V2500-A5 SERIES PROPULSION SYSTEM SERVICE BULLETIN

This document transmits the Initial Issue of Service Bulletin V2500-ENG-73-0203

V2500-ENG-73-0203

ENGINE – FUEL AND CONTROL – PROVIDE A NEW ELECTRONIC ENGINE CONTROL (EEC) WITH A5
SCN20/Y SOFTWARE

FAMILY TREE - ELECTRONIC ENGINE CONTROL (EEC) REF. CATALOG SEQUENCE NO. 73-22-34.
 FIG. 01 ITEM 280 - FOR V2500-A5 DELIVERED ENGINES
 CHART A (SHEET 1 OF 4)

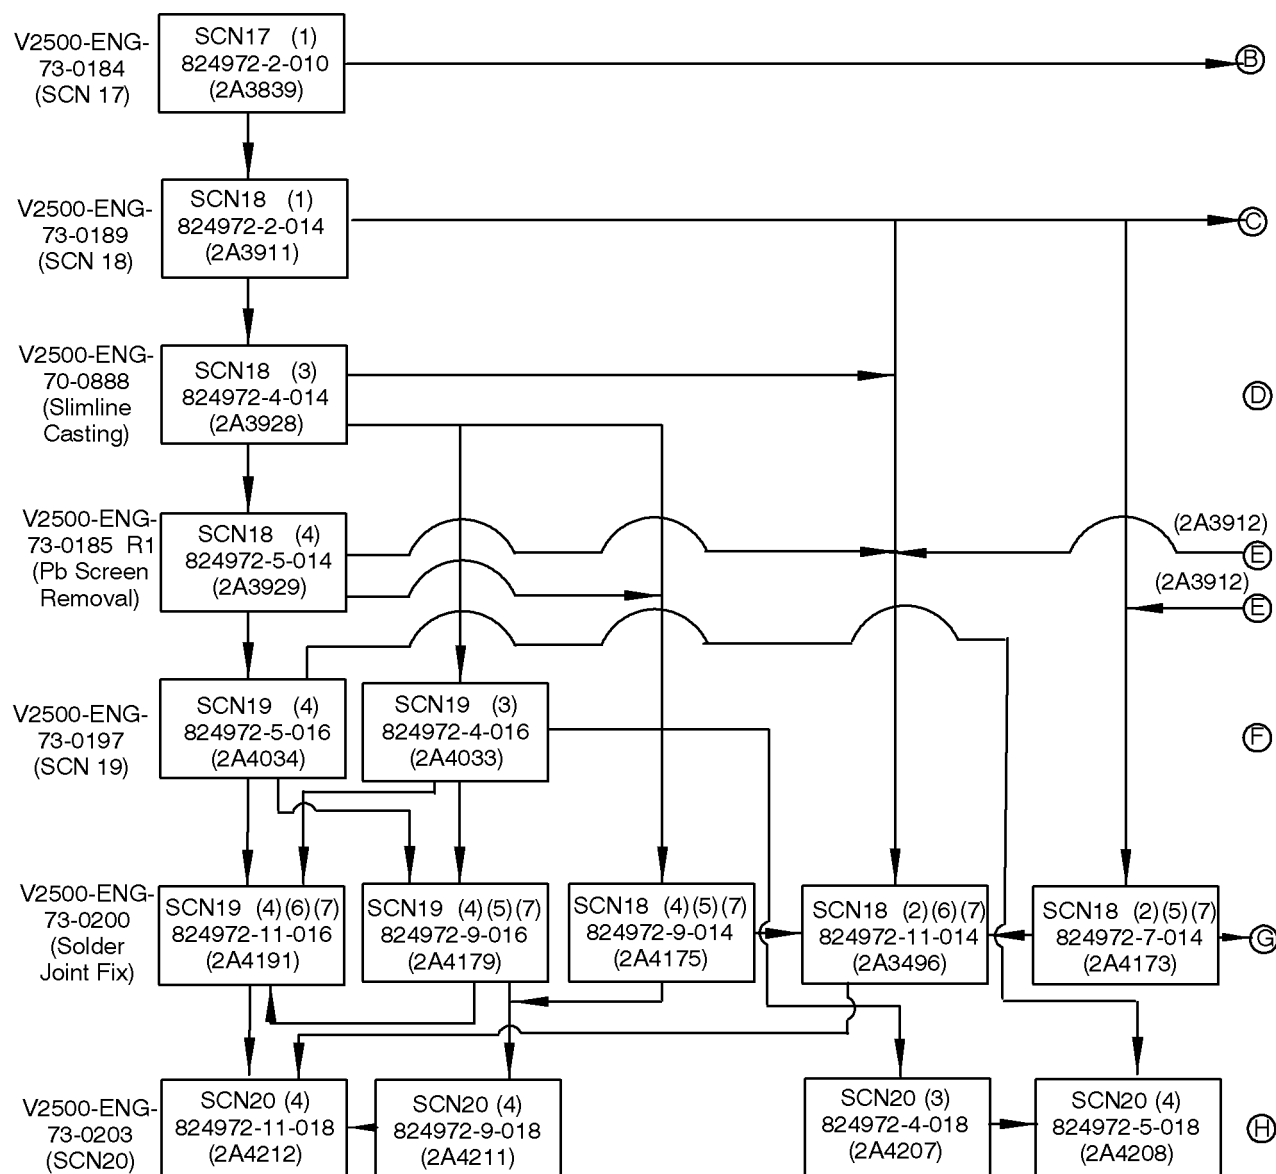
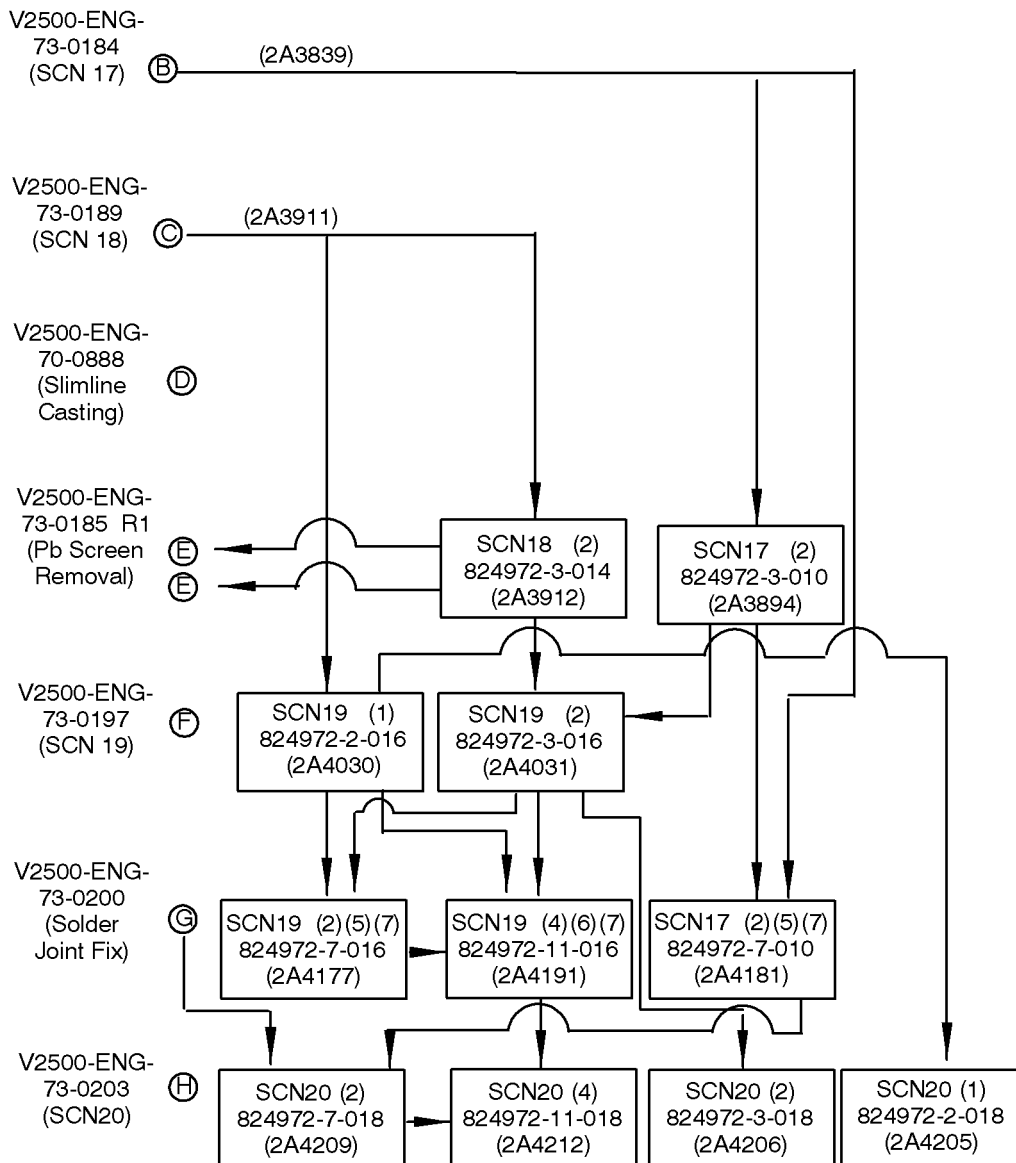
- (1) With Pb Screen
 (2) No Pb Screen
 (3) With Pb Screen & Slimline Case
 (4) No Pb Screen & Slimline Case
 (5) The new part can be obtained by modification of the old part as specified in the Accomplishment Instructions.
 (6) The new part is a replacement part only, and cannot be obtained by modification of the old part.
 (7) With Reference 7, Service Bulletin No. V2500-ENG-73-0185 incorporated.

FAMILY TREE - ELECTRONIC ENGINE CONTROL (EEC) REF. CATALOG SEQUENCE NO. 73-22-34.
FIG. 01 ITEM 280 - FOR V2500-A5 DELIVERED ENGINES
CHART A (SHEET 2 OF 4)

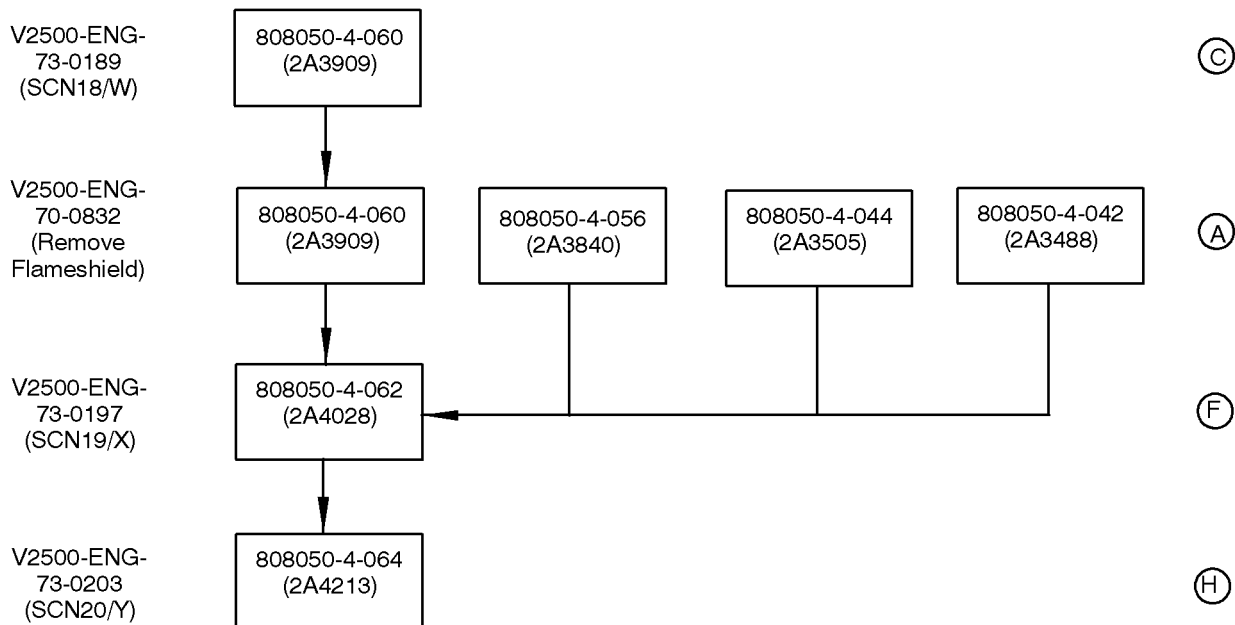
- (1) With Pb Screen
- (2) No Pb Screen
- (3) With Pb Screen & Slimline Case
- (4) No Pb Screen & Slimline Case
- (5) New part can be obtained by modification of the old part as specified in the Accomplishment Instructions.
- (6) New part is a replacement part only, and cannot be obtained by modification of the old part.
- (7) With Reference 7, Service Bulletin No. V2500-ENG-73-0185 incorporated.

FAMILY TREE - ELECTRONIC ENGINE CONTROL (EEC) REF. CATALOG SEQUENCE NO. 73-22-34.
FIG. 01 ITEM 280 - FOR V2500-A5 DELIVERED ENGINES
CHART A (SHEET 4 OF 4)

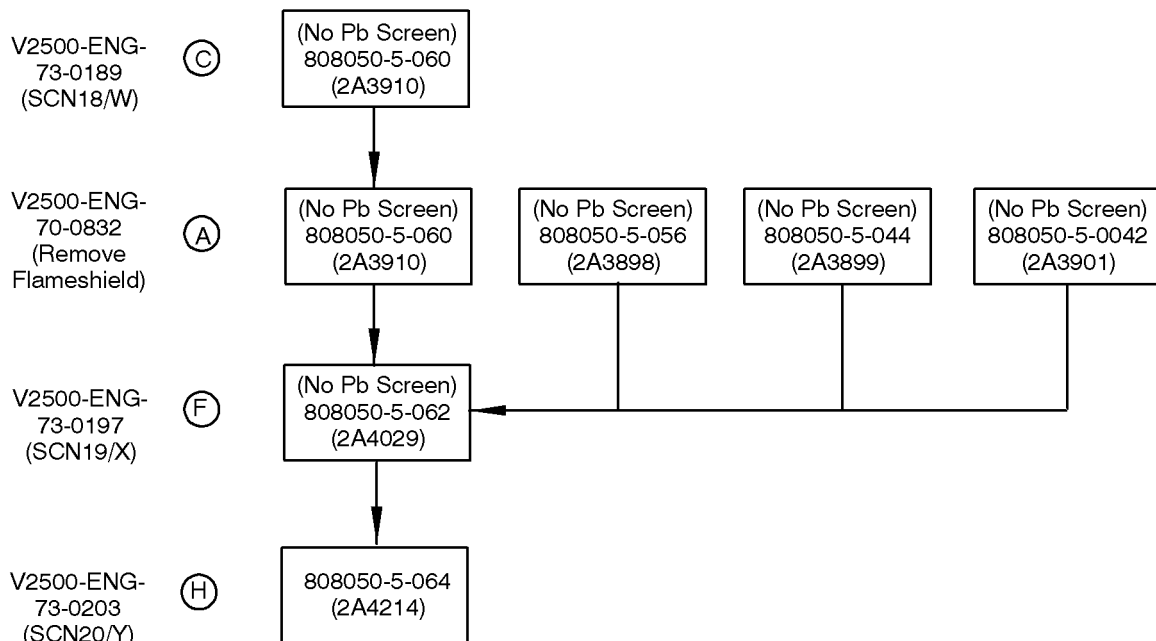
MODIFICATIONS

PART NUMBER CHANGE
